Community Development Staff Report

RE: 227 7th Avenue West - The Cedars

FILE #: P20-09-CZD

DATE: January 7th, 2021

Sheet No.:
AS101

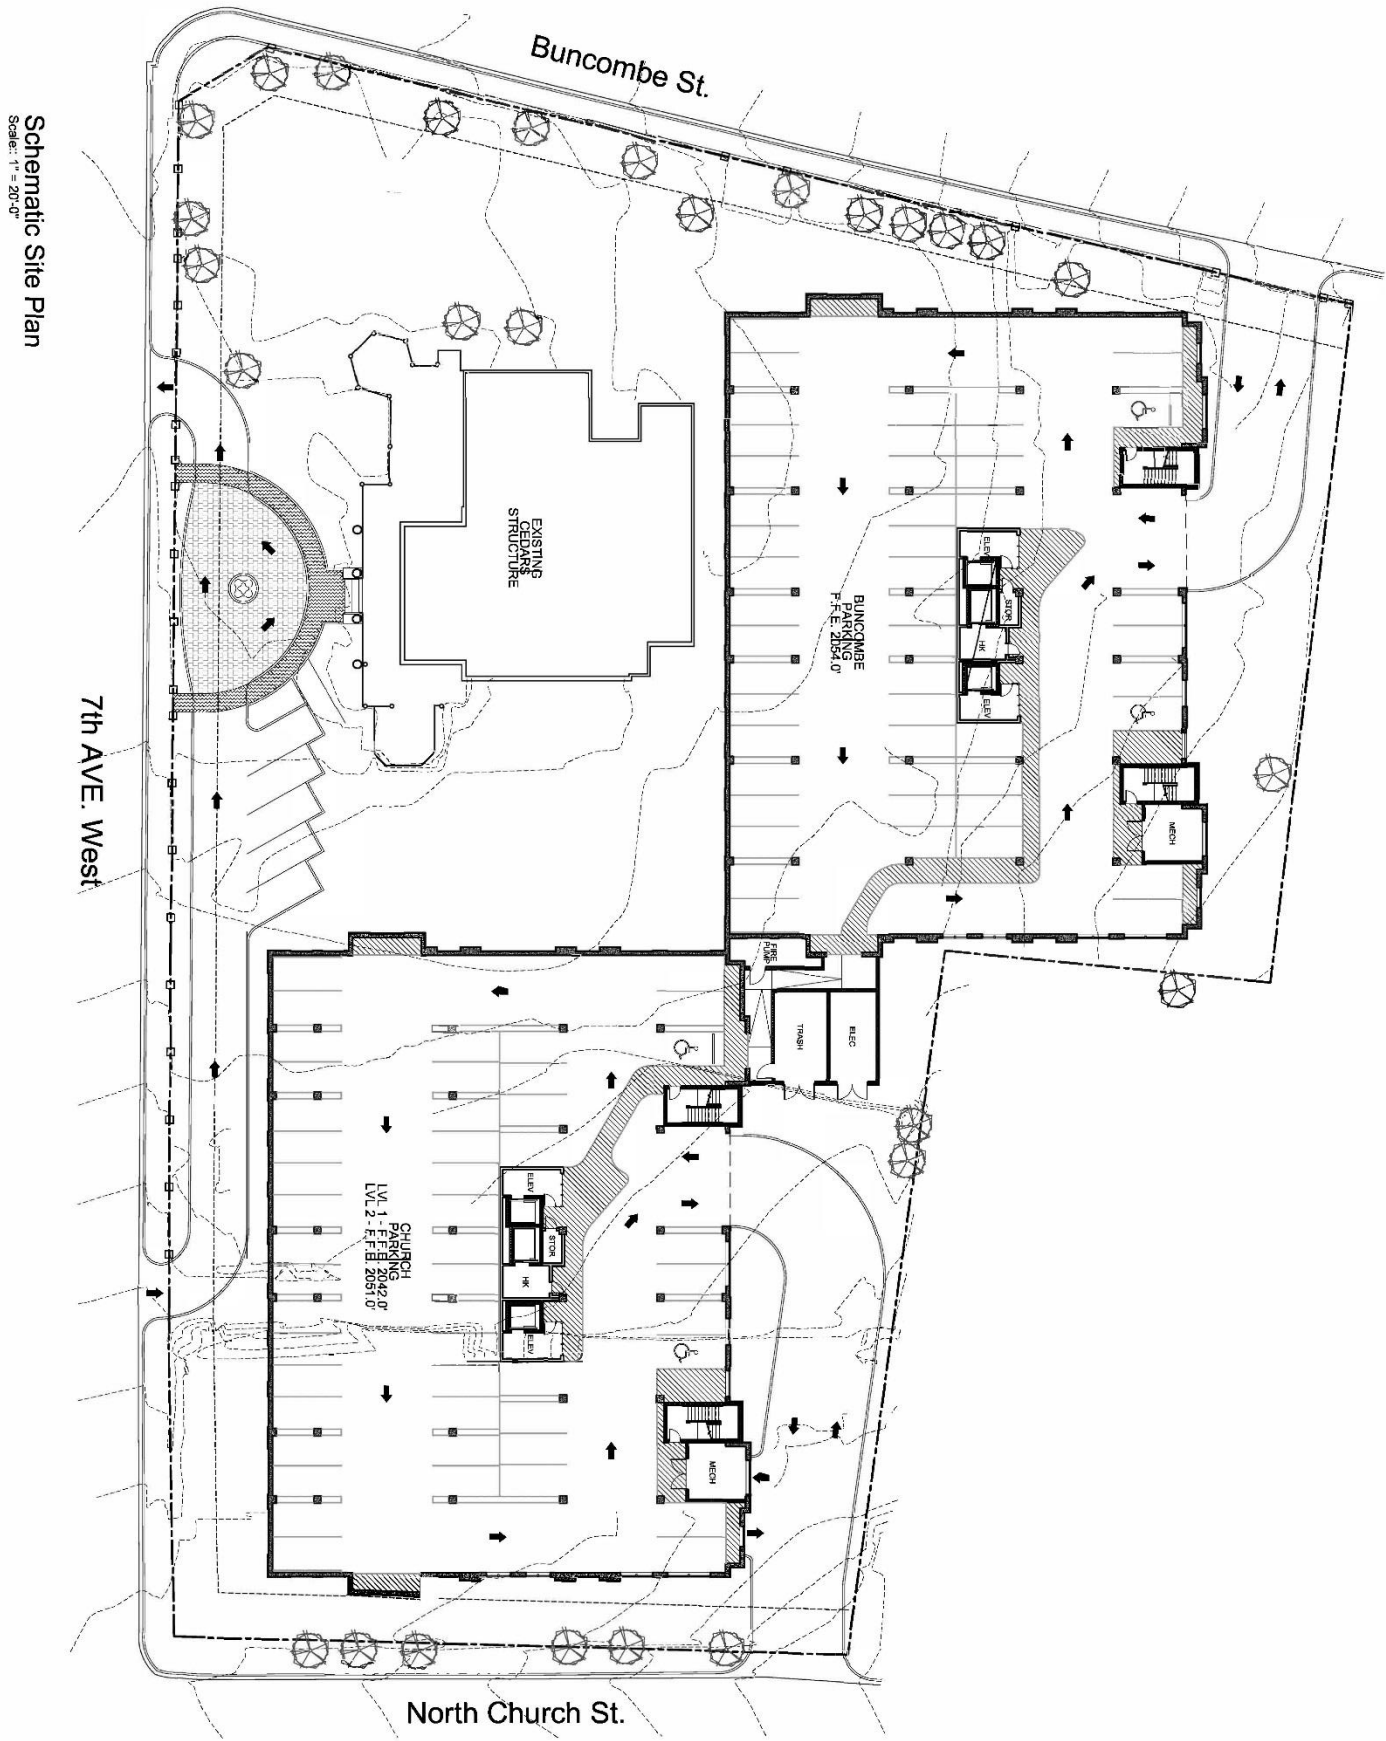
General comments regarding the above; while this information is available via the total package submission, it needs to be consolidated onto a “Schematic Site Plan.” In the package submitted it would appear this might be considered page AS101, which is not sufficient. Staff recommend that the schematic site plan be set-up more like the “Utility Plan – C201” in the package.

- 1) Proposed Urban Open Space is included in site calculations but not identified on Schematic Site Plan.
- 2) **Comment:** Include and highlight the proposed area that will meet the standards established in Section 5-19-3.3 f) Urban Open Spaces. Also please note the maintenance provisions via note.

- 1) It does appear that existing vegetation is being preserved, but this is not clearly identified on the schematic site plan.
- 2) **Comment:** Please include the tree(s) (species & DBH) that will be preserved as a component of the revised schematic site plan. Please note the tree preservation standards that will be applied. This information can be included as a component of the planting plan if the two are to be kept separate.

- 1) **Comment:** Please include basic dimensions on building footprint.

SHEET
NAME:
Elevations

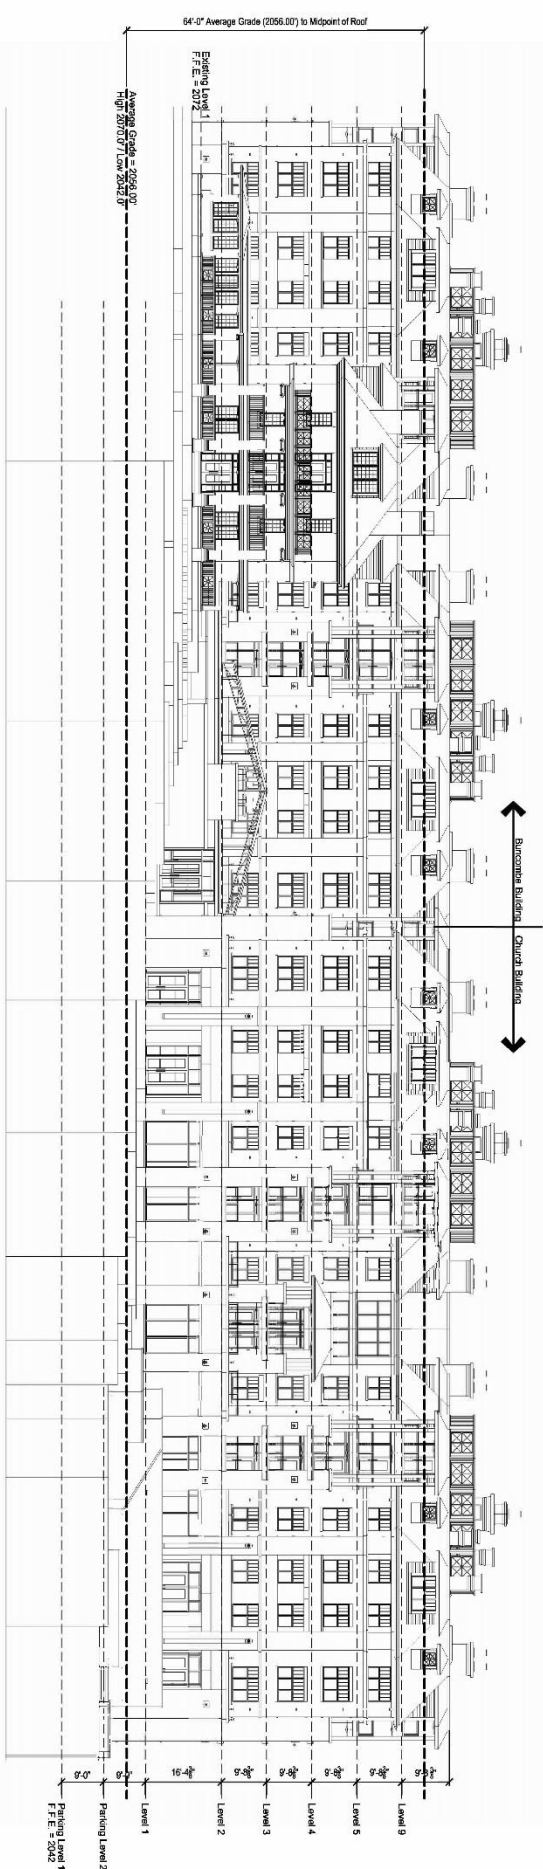
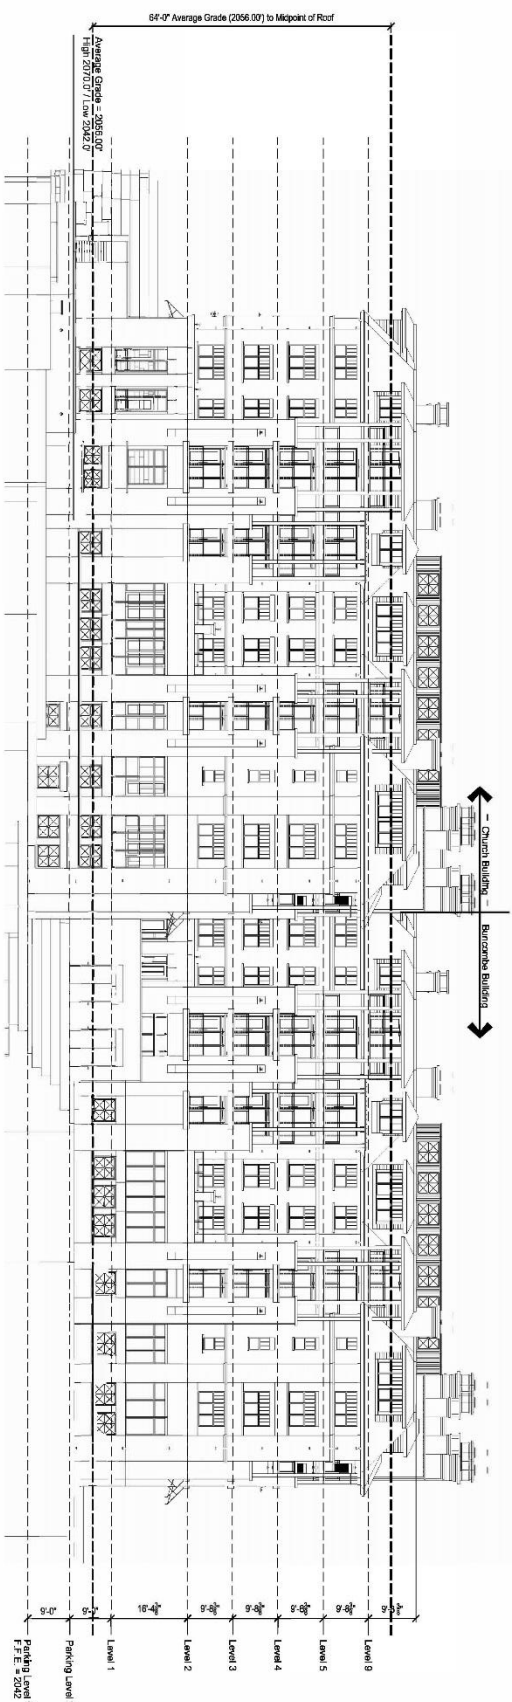
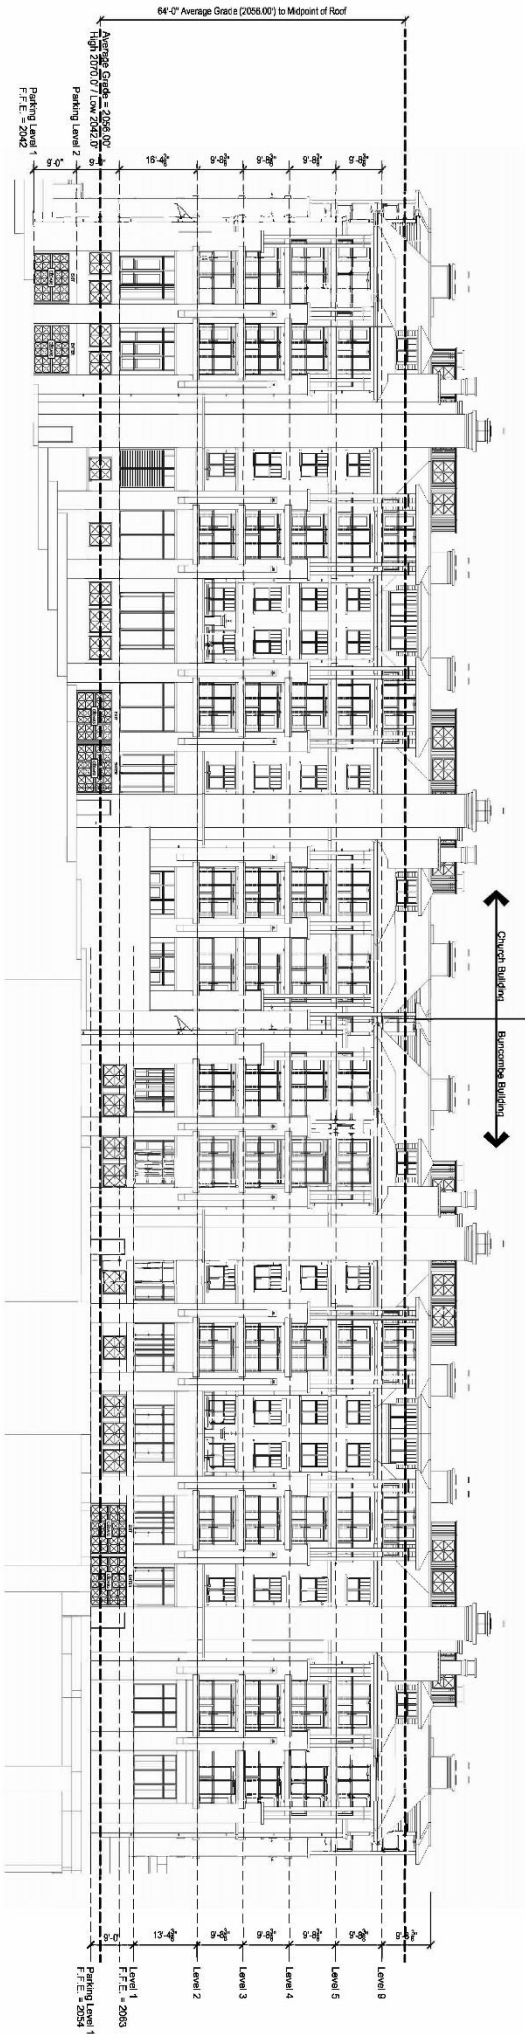
- 2) *That the "Elevations" provided as a component of the CZD application be amended to the height measured from the roof deck line on the mansard roofs.*

- 3) *With the "Average Grade" established as described above and the point of measurement for the height of the mansard roof adjusted, the building(s) then be shown to meet the 64' height limitation.*

- a. Conditions 1 – 3: Staff have worked with the developer to establish how to measure these elements and believe that they are, at a schematic level, meeting the requirements of the height restriction as measured by the described method.
